**BID ADDENDUM NO. 3**

PROJECT NAME: PORT CHESTER HIGH SCHOOL ADDITIONS, ALTERATIONS  
AND ATHLETIC FIELD

F&D PROJECT #: PCHS # 17295.03

DATE: February 21, 2019

**DRAWING TITLE:**  
REFERENCE DRAWING S302 SECT. 1

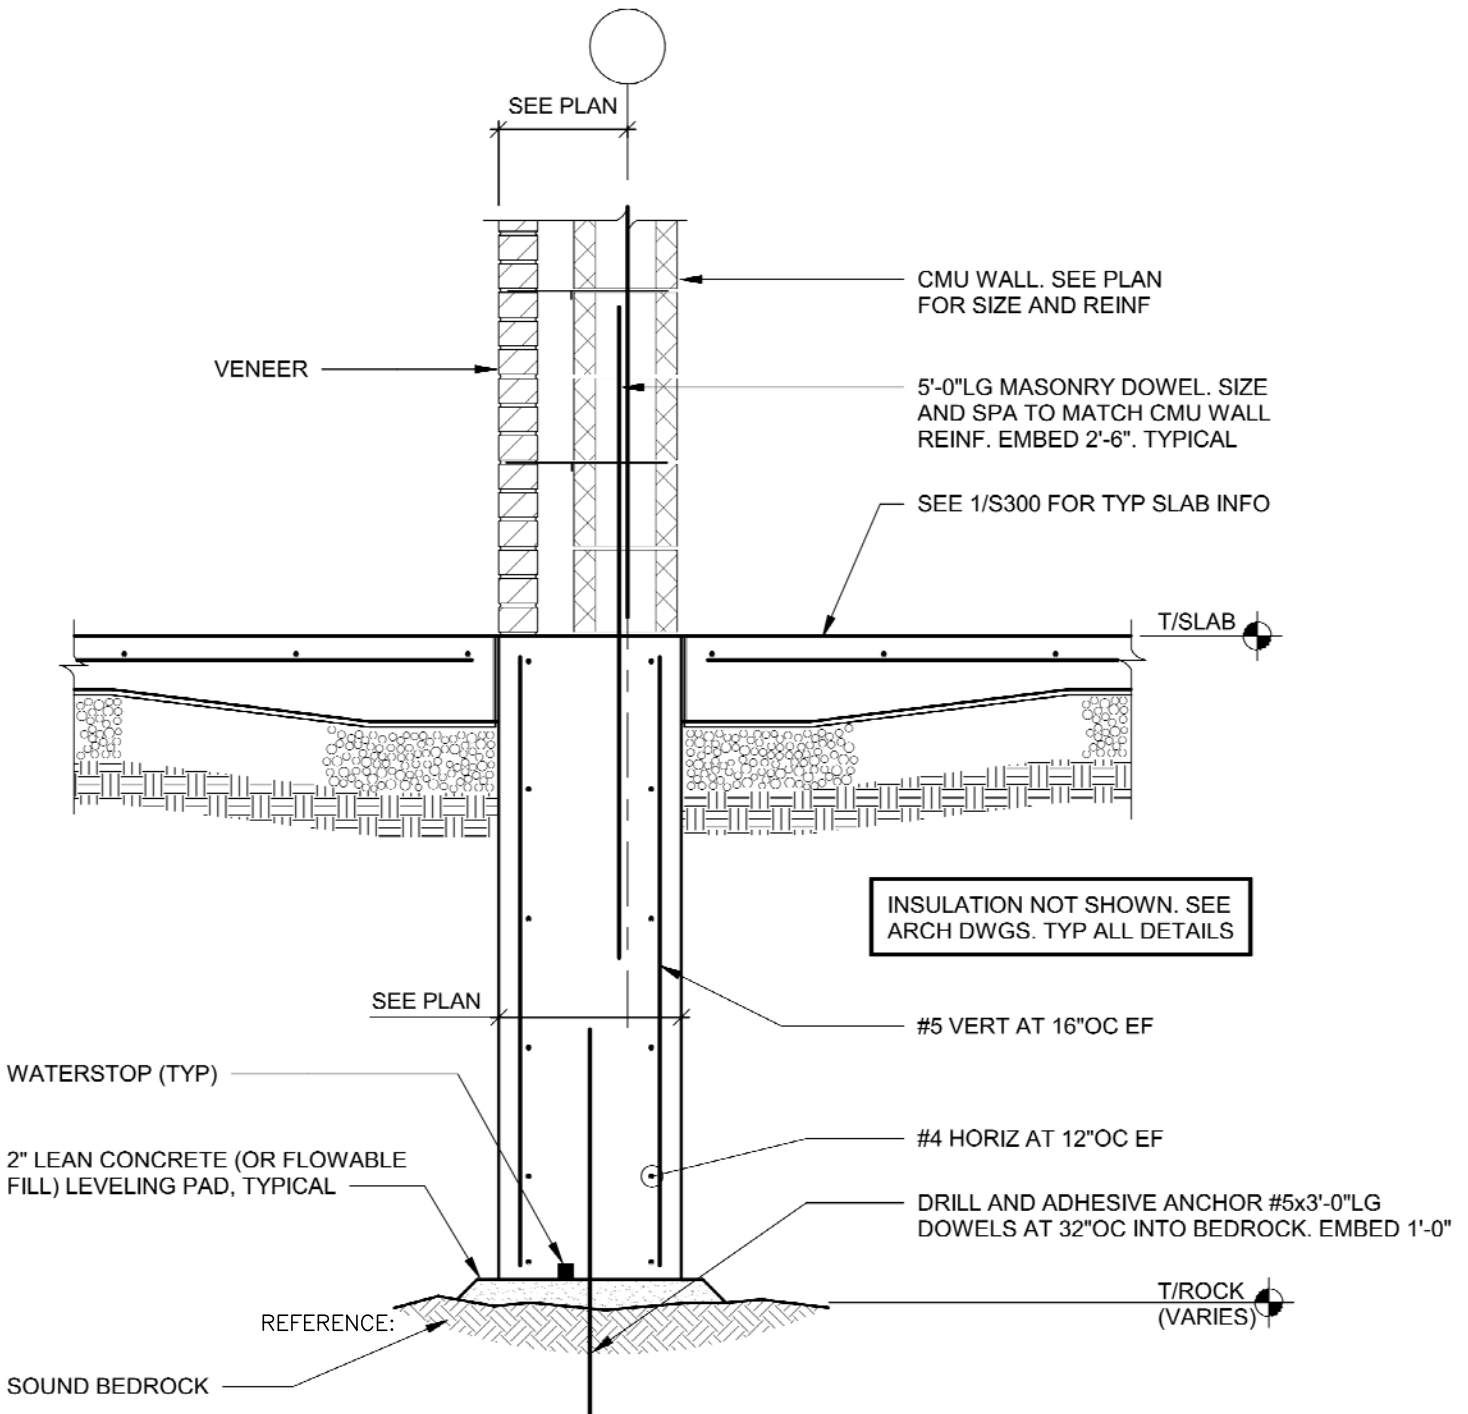
**1 SECTION**  
SCALE: N.T.S.

**DRAWING TITLE:**  
REFERENCE DRAWING S302 SECT. 2

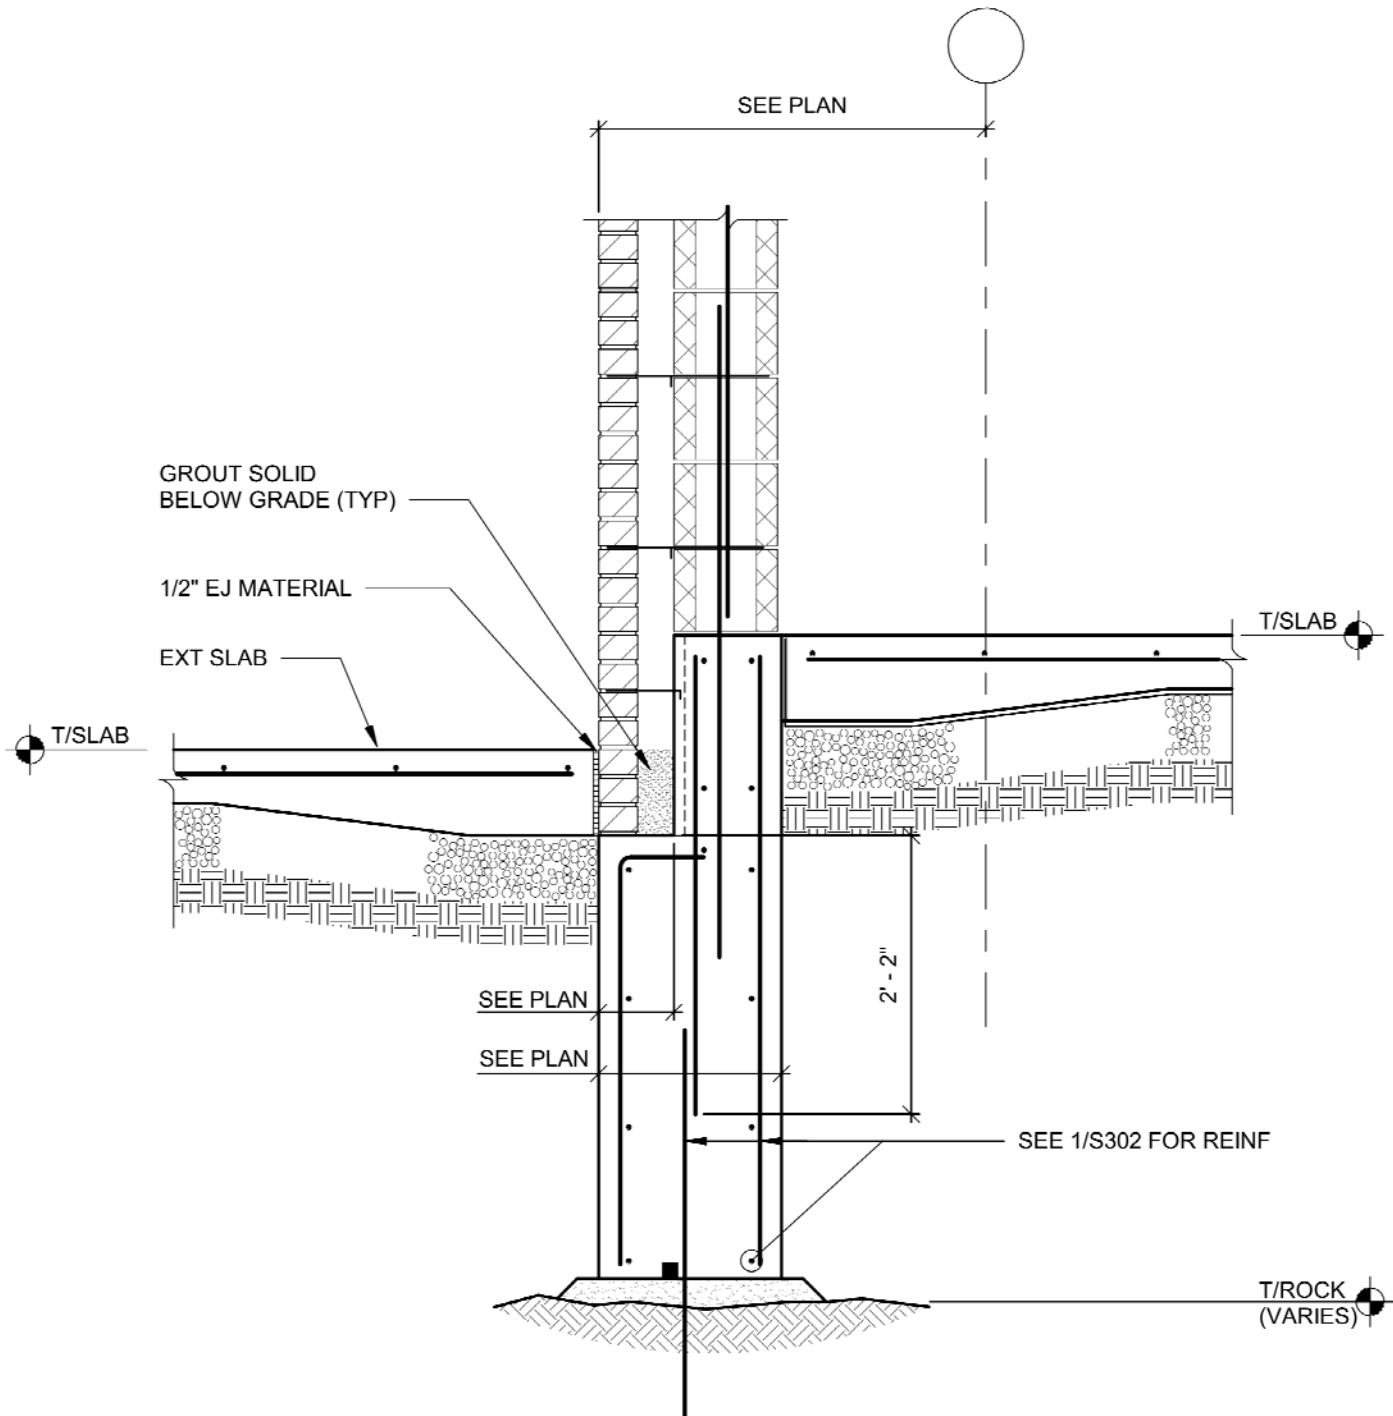
**2 SECTION**  
SCALE: N.T.S.

**DRAWING TITLE:**  
REFERENCE DRAWING S303 SECT. 5

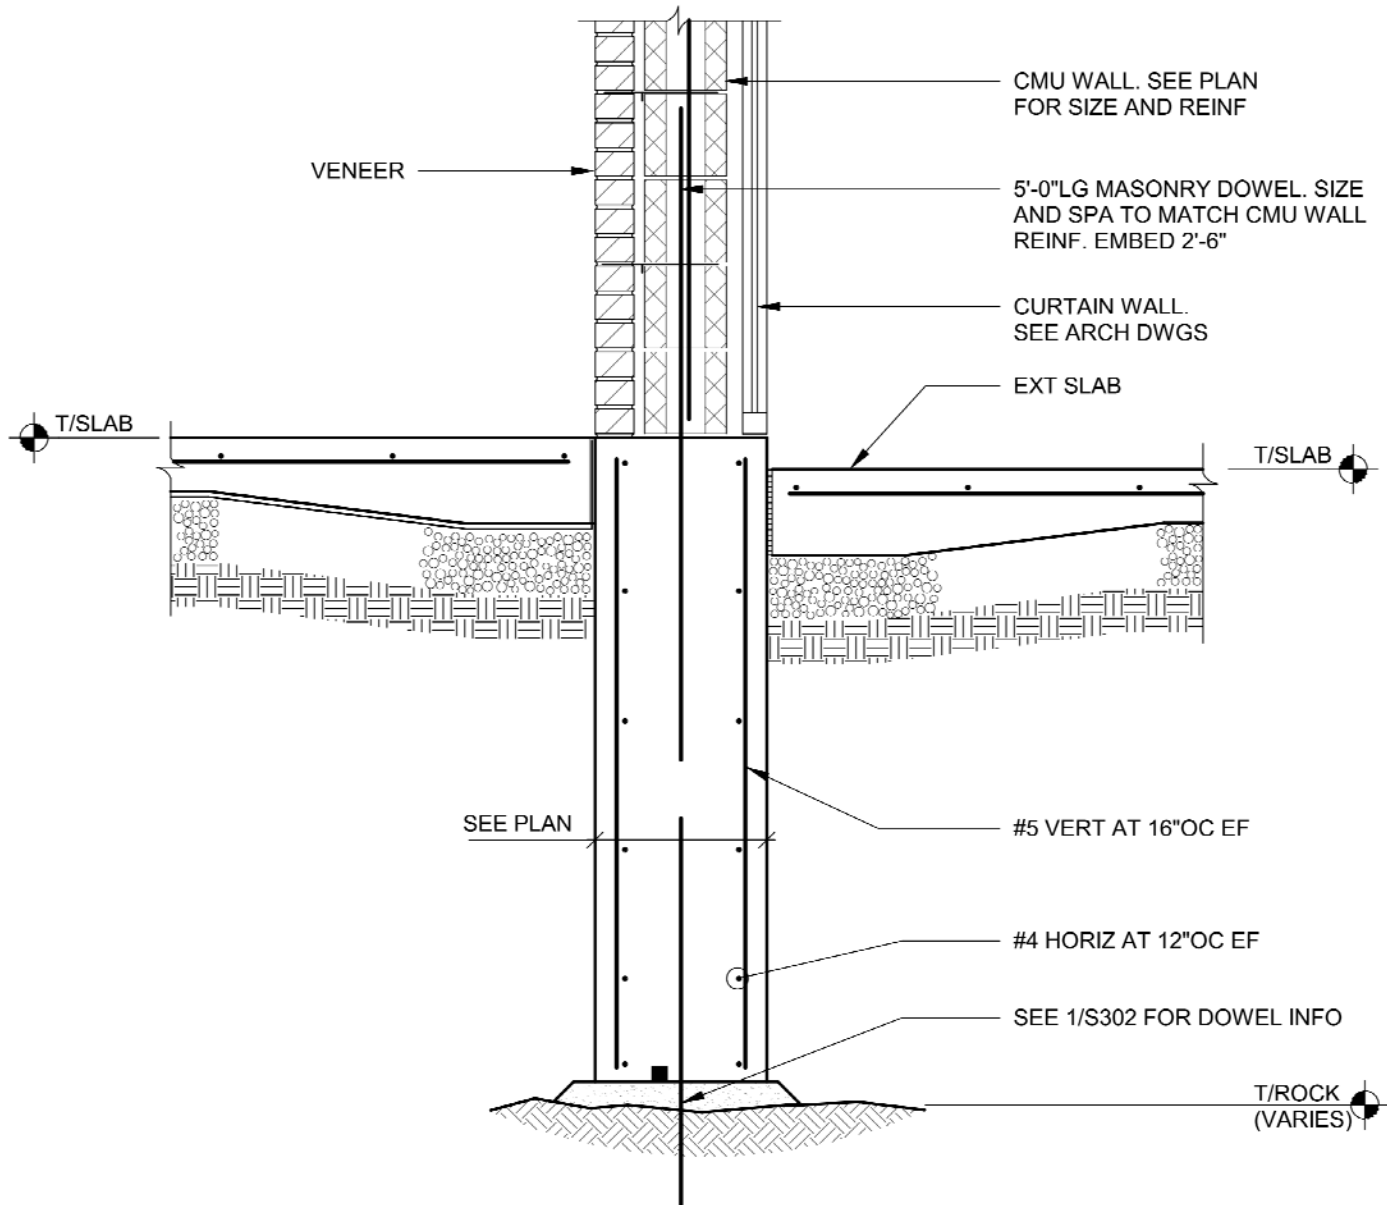
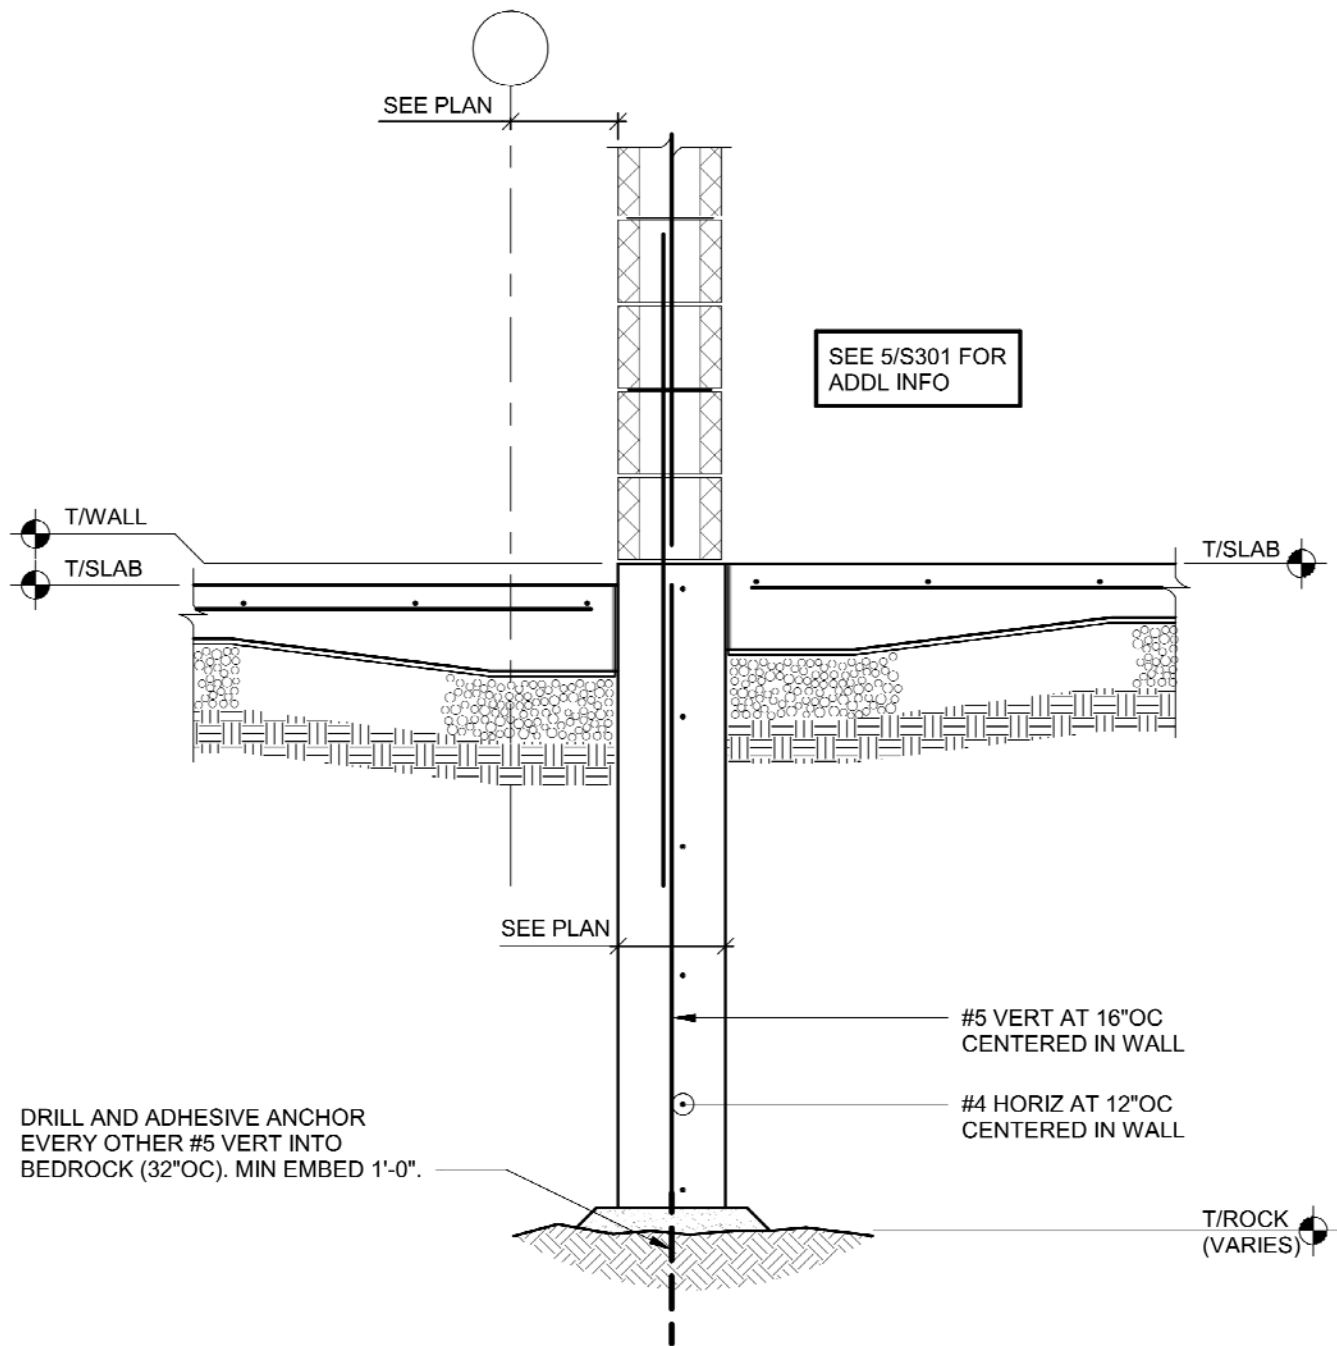
# 5 SECTION
